AltoUpdate...

MAKE	TRANSMISSION	APPLICATION	YEAR
Ford	E40D, 4R100	Light Truck	89-0n
DESCRIPTION & NOTES...

NEW TO ALTO! Overdrive PowerPack® #026758...

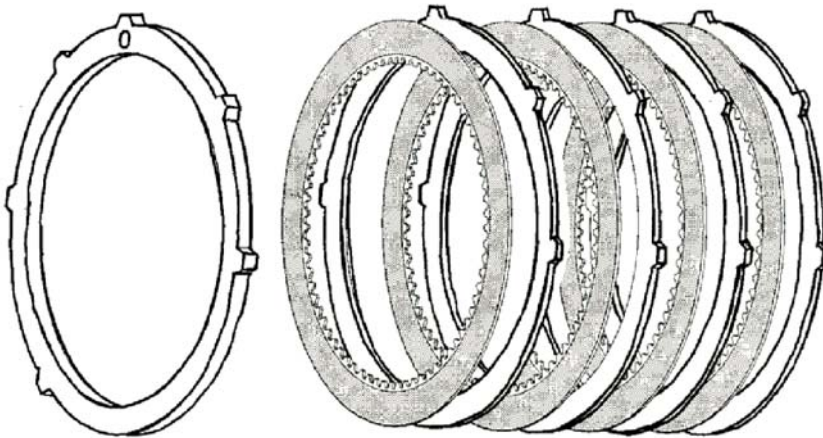
The Problem:

Premature failure of the overdrive clutch due to high torque applications, when subjected to a hi-performance or heavy-duty environments. The overdrive clutch can fail under these conditions, including hot-spotting the steel plates, along with slide-bump shifts.

The Solution:

Alto Products Corp. is pleased to release a capacity kit for the overdrive section of the E40D / 4R100 transmissions. We have added one more friction and steel element to increase the capacity of the overdrive clutch, along with Red Eagle® friction lining, which will dramatically increase the amount of torque the overdrive clutch can handle.
